From: Scala, Mary Joy
Sent: Tuesday, December 07, 2010 4:47 PM
To: McHugh, Kathy
Cc: 'John Quale'; 'Marilyn W. Moedinger'
Subject: 608 Ridge Street

From: Scala, Mary Joy
Sent: Monday, December 06, 2010 4:24 PM
To: Brian Hogg; Candace DeLoach; Eryn Brennan (work); Eryn Brennan personal; Faxayres@gmail.com; Fred Wolf; Michael Osteen; Preston Coiner; Syd Knight; William Adams
Subject: 608 Ridge Street Eco ReMOD revision
Attachments: 608 Ridge Street.pdf

608 Ridge Street Front casement window frames

Photo 2 of 9 [View All](#)

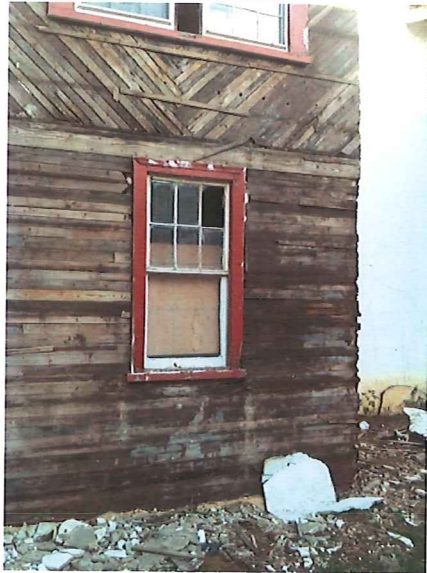
We have removed the stucco from the "tower" section to reveal a bunch of T&G sheathing. Due to the amount of rot, the narrow width, and the short lengths of the existing material I wanted to discuss the feasibility of the plan to reuse the old sheathing as siding. It seems that a more economical plan may be to remove and replace the rotten sections with new sheathing, wrap the existing structure / sheathing with house wrap, and construct a rain-screen with new material (new wood slats or another siding material). I just wanted to open this discussion and see if we are open to alternatives at this point now that we know the condition of the existing material.

Also, the album includes two images of the existing rafter tails on the front porch roof. These were covered by a thin luan plywood soffit. I could not find a detail in the plan set that shows the new trim here. do we leave the rafter tails exposed with a new fascia (typical) or do we replace the soffit? Obviously leaving the rafter tails exposed would be more historically accurate but I just wanted to run it by you.

What they want to do instead of refinishing the wood is to use hardie smooth horizontal siding with 6" overlap, painted the same tan color as the stucco on the rest of the house. The rainscreen they mention consists of slats of wood under the hardie that will not be visible.
